SERVICE BULLETIN

MODEL NAME : Di620
MODEL CODE : 1155
NO. : 005
DATE : 980702
SUBJECT : HARNESS CHANGE

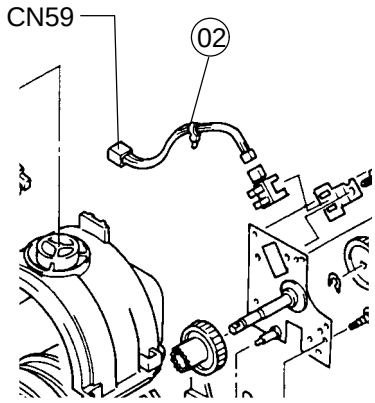
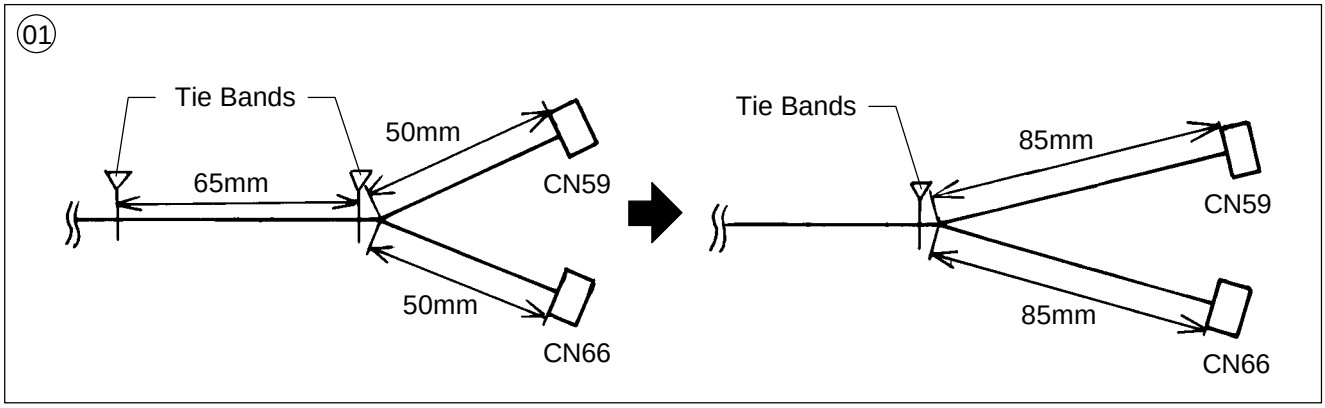
To increase production efficiency, the following modifications have been implemented.

1. For harness 01, the position of the tie band has been changed.
2. For harness 01 and 02, CN59 was changed from a CT connector to an SMP connector.

NOTE: The new harnesses (01, 02) must be installed in premodification machines together as a set.
